APPLICATION NO.	FILING DATE	FIRST NAMED INVENTOR	ATTORNEY DOCKET NO.	CONFIRMATION NO.	
10/659,085	09/09/2003	Lawrence H. Freedlund	P02734	2728	
28548 7	7590 05/04/2006		EXAMINER		
STONEMAN LAW OFFICES, LTD 3113 NORTH 3RD STREET PHOENIX, AZ 85012			CHIN, PAUL T		
			ART UNIT	PAPER NUMBER	
,			3652	3652	
				DATE MAILED: 05/04/2006

Application No.	Applicant(s)				
	10/659,085	FREEDLUND, LAWRENCE H.				
Office Action Summary	Examiner	Art Unit				
	PAUL T. CHIN	3652				
The MAILING DATE of this communication app Period for Reply	ears on the cover sheet with the c	orrespondence address				
A SHORTENED STATUTORY PERIOD FOR REPLY IS SET TO EXPIRE 3 MONTH(S) OR THIRTY (30) DAYS, WHICHEVER IS LONGER, FROM THE MAILING DATE OF THIS COMMUNICATION. - Extensions of time may be available under the provisions of 37 CFR 1.136(a). In no event, however, may a reply be timely filed after SIX (6) MONTHS from the mailing date of this communication. - If NO period for reply is specified above, the maximum statutory period will apply and will expire SIX (6) MONTHS from the mailing date of this communication. - Failure to reply within the set or extended period for reply will, by statute, cause the applic

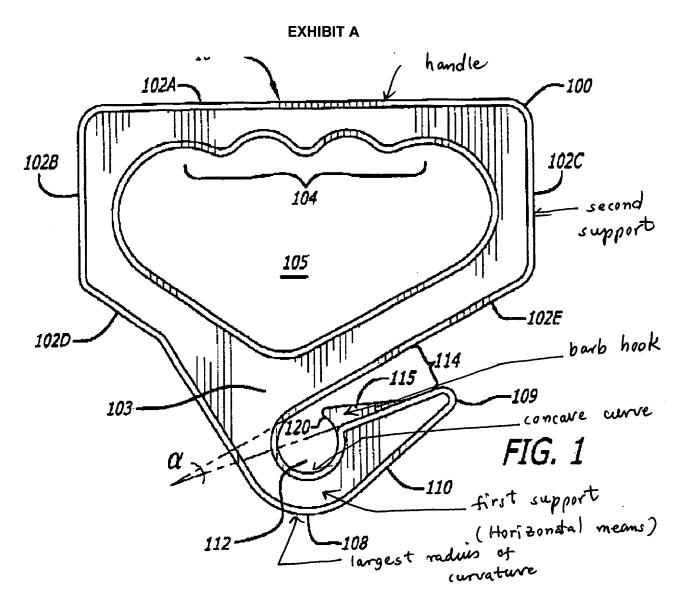
Le Roux (6,883,207) discloses a handgrip holding system comprising at least one holder having at least one extended loop handle (Fir. 1) for carrying at least one shopping bag, a first support 108 having a substantially horizontal surface means, and transit means 110 having a barb hook (120), a second support 102 for support the first support, wherein the second support means comprises a handle 100 and the first support comprises a concave curve (see Exhibit A).

Re claims 2 and 8, figure 1 shows a centering means.

Re claims 3 and 9, Exhibit A shows the concave curve has a substantially similar radius of curvature as the largest radius of an external perimeter of the holder.

Re claims 5 and 11, figure 1, as best understood, shows the barb hook (120) being located above the concave curve.

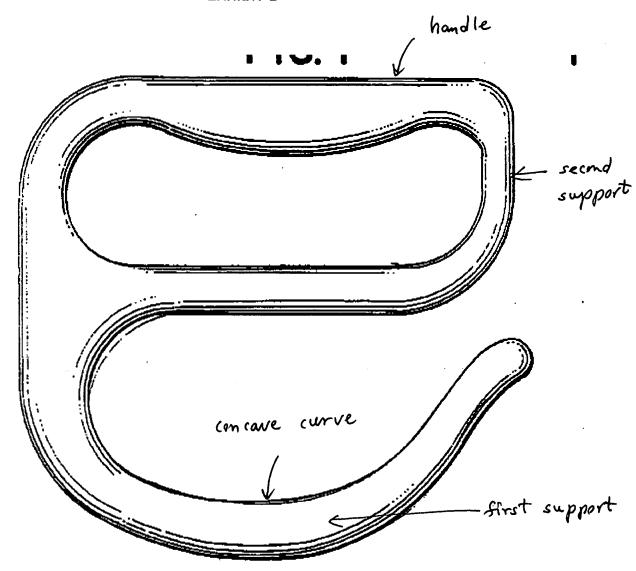
Miceli, Jr. (Des. 356,261) shows a handgrip holding system (see Exhibit B, next page) comprising at least one holder for carrying at least one shopping bag, having a first support having a substantially horizontal surface means, and transit means, a second support for support the first support, wherein the second support means comprises a handle and the first support comprises a concave curve (see fig. 1). Micelle, Jr. (Des. 356,261) does not show a barb hook. However, Kosteniuk (5,645,306) teaches a barb hook (40) to block an accidental slipping of the carried bags. Accordingly, it would have been obvious to those skilled in the art to provide a barb hook on the first horizontal means of Miceli, Jr. (Des. 356,261) as taught by Kosteniuk (5,645;306) to block the slipping of the carried bags.

Re claims 2 and 8, figure 1 shows a centering means located in the middle of the handle 12.

Re claims 3 and 9, figure 1 substantially shows the radius of curvature of the first support has substantially similar radius of curvature as the largest radius of an external perimeter of the holder.
